Vale of White Horse Local Plan (Part 1) 2011-2031

Statement by Oxfordshire County Council

Matter 7

Supporting Infrastructure and Services

E3 - Harwell Link Road (B4493 to A417) and Southern Didcot Spine Road

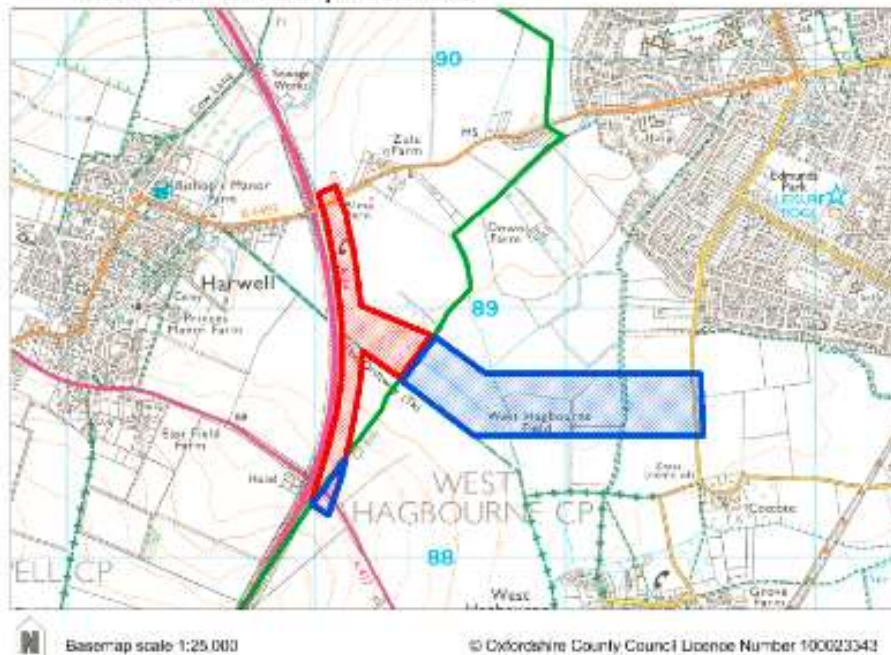
The current safeguarding map includes an error as it shows land in South Oxfordshire District in red hatching. The amended map below shows the part of the Harwell Link Road within South Oxfordshire clearly in blue. A slightly reduced area is shown for the Southern Didcot Spine Road within Vale of White Horse. A blue area is shown where the Southern Didcot Spine Road could be located in South Oxfordshire. The blue areas are advisory only and will not be shown on the Policies Map.

E4 - A34 Chilton Interchange

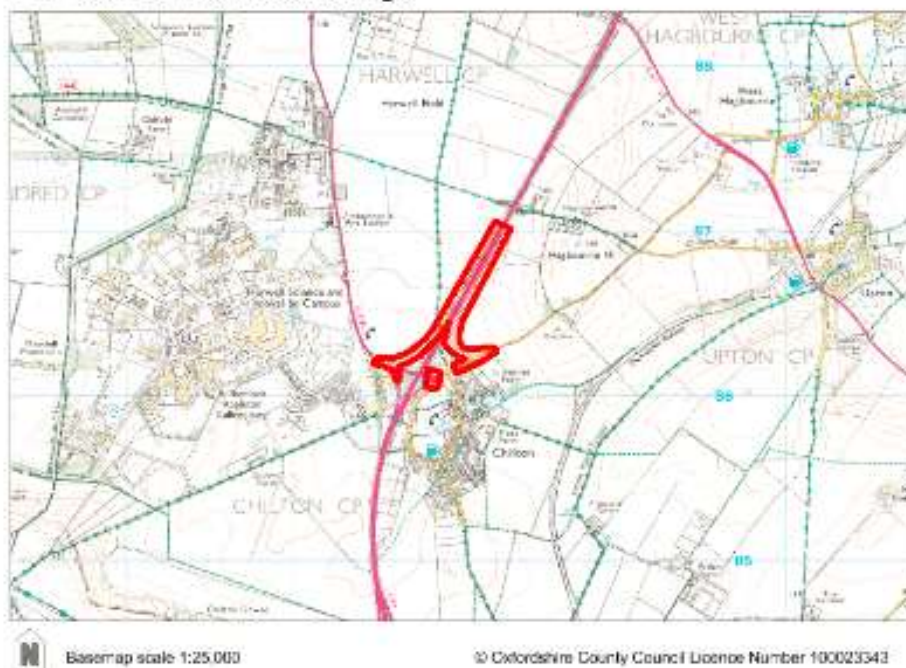
A minor amendment to the safeguarding maps reflects the current scheme and provides that land be safeguarded should the slips need to be lengthened in future to cater for any additional growth.

E7 - Science Bridge

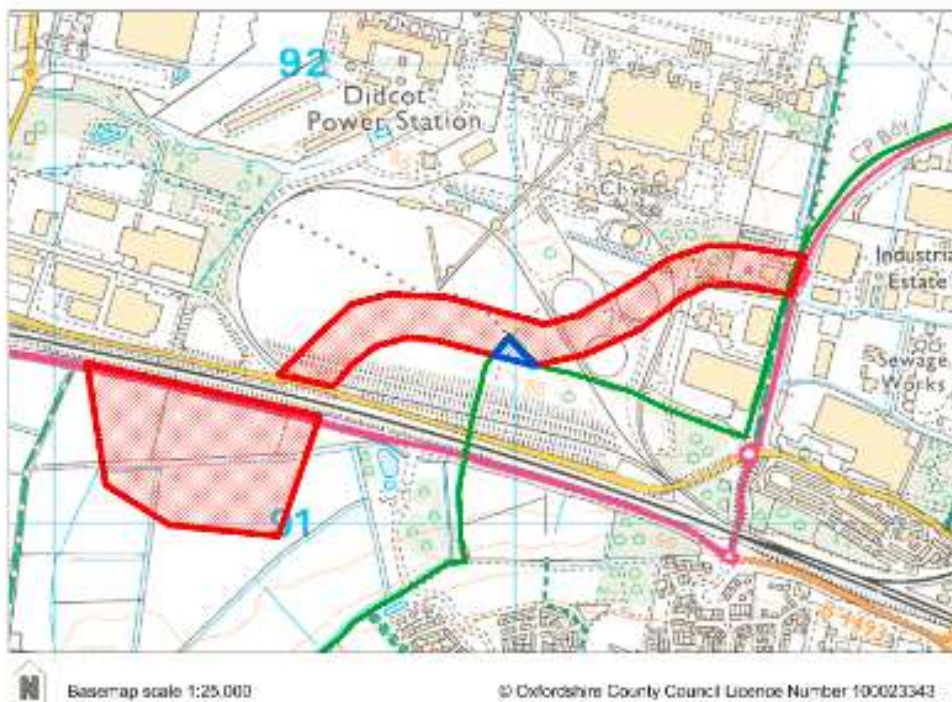
Amendments are required to the safeguarding map to clarify the land required for the bridge and connections. The blue area within South Oxfordshire is advisory only and will not be shown on the Policies Map.

New title: Science Vale Thames Crossing, Culham Science Centre

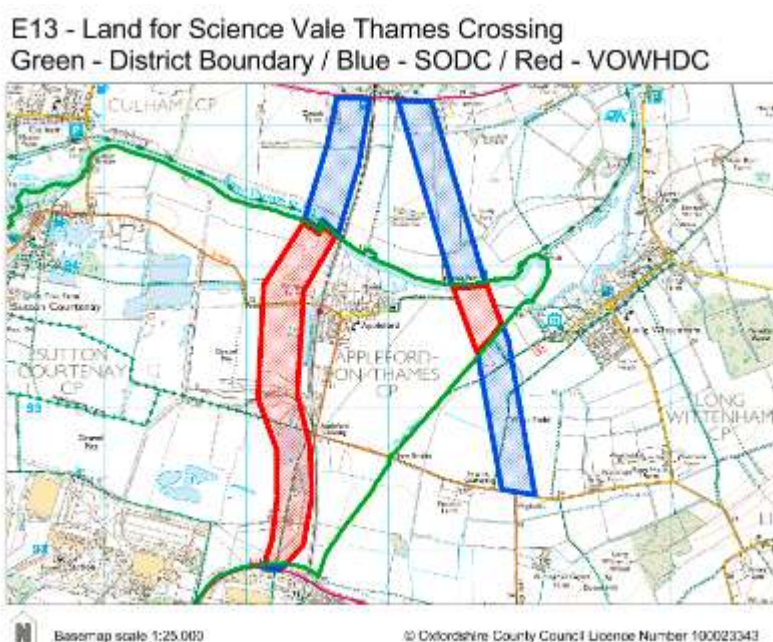
The safeguarding map as submitted identified a wide area where it was considered a route would be found. As noted in the County Council comments on the Submitted Plan, the current safeguarding includes scheduled ancient monuments. Feasibility work on four alternative routes has been undertaken in 2015, with two options emerging as viable. The two options are not contained within the submitted safeguarding area. Further design work on the two alignments will continue to be undertaken.

Amendments to the safeguarding map are intended to reflect the options, rather than the out of date area. The blue areas showing how the options relate to land in South Oxfordshire are advisory only and will not be shown on the Policies Map.

E15 - Land for Abingdon Southern Bypass

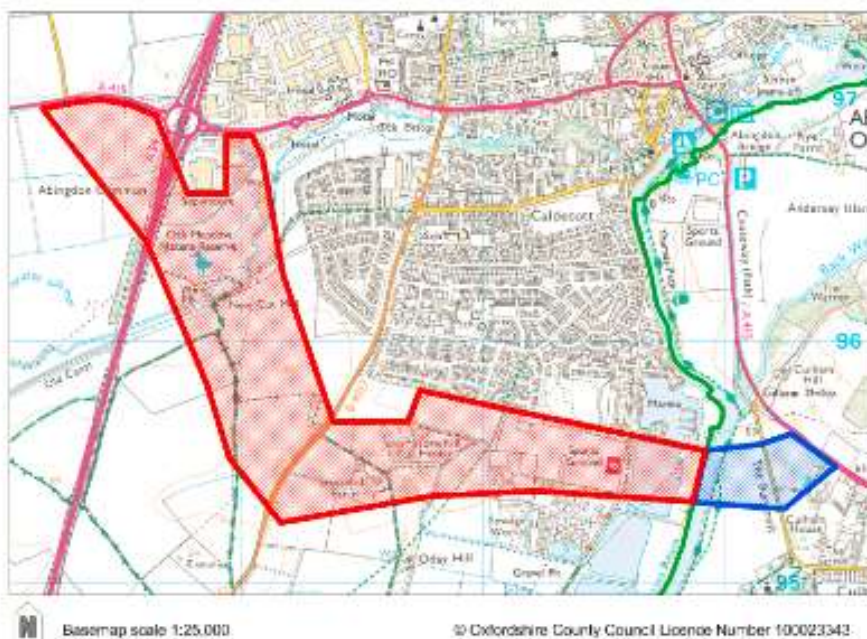
Amendments are proposed for the safeguarding map to provide for additional land given that some of the land originally identified in the Submitted Plan is now being developed in accordance with a planning consent and to reflect possible route alignments. No detailed work has been undertaken to date, so there has been no attempt to amend the map to avoid the scheduled ancient monument, but it is clear that the map as included in the Submitted Plan would not provide sufficient land for a South Abingdon Bypass given the land being developed and therefore additional land to the south has been identified. The

blue area showing how the road could connect into South Oxfordshire is advisory only and will not be shown on the Policies Map.

E17 - Shrivenham Junctions with A420

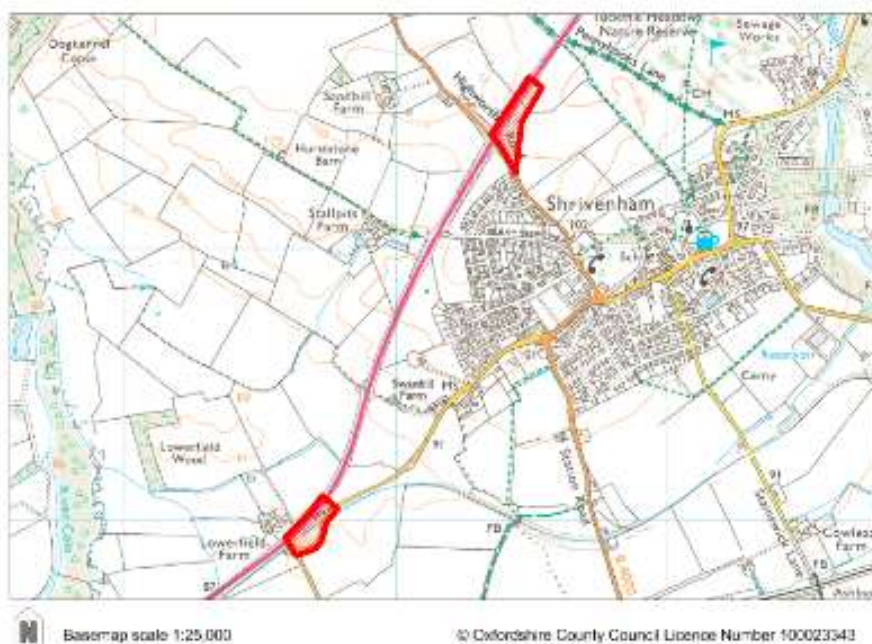
The Submitted Plan safeguarding map only includes land at Townsend Road, where there is an existing access from the A420. However, the North of Shrivenham site abuts the A420 and there is an opportunity for a new access onto the A420 in that location using that land. The County Council has sought such a new access in respect of the applications for that site (P13/1810/O and P15/V2541/O). LTP4 specifically refers to the need for a Highworth Road junction.

It is not clear why the land at North Shrivenham was not safeguarded. It may have been overlooked given the late incorporation of this draft allocation, or it may be that it was considered unnecessary to safeguard land that was already the subject of a draft allocation. As the land required for improving the Townsend Road junction is outside of the control of the landowners at North Shrivenham, it better meets the needs of that site and the tests for compulsory purchase to create a new access here rather than seek to improve the existing Townsend Road junction as a condition of consent to development on that land.

Amendments are required to the safeguarding map to provide for sufficient land to enable a junction at Highworth Road in addition to that which may be required to improve the Townsend Road junction.

E18 - Coxwell Road Junction

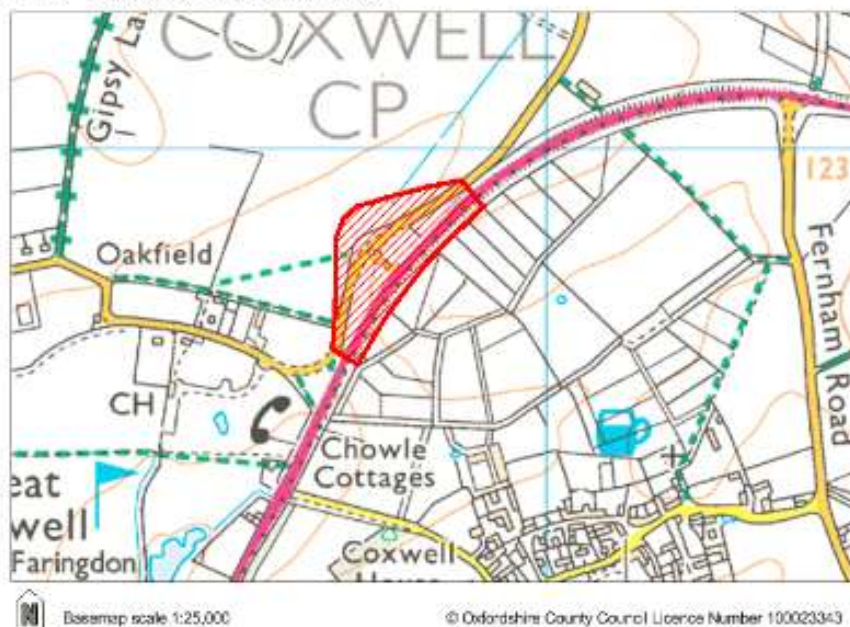
An amendment is required to the safeguarding map involving slightly more land to reflect the latest draft designs for a roundabout.
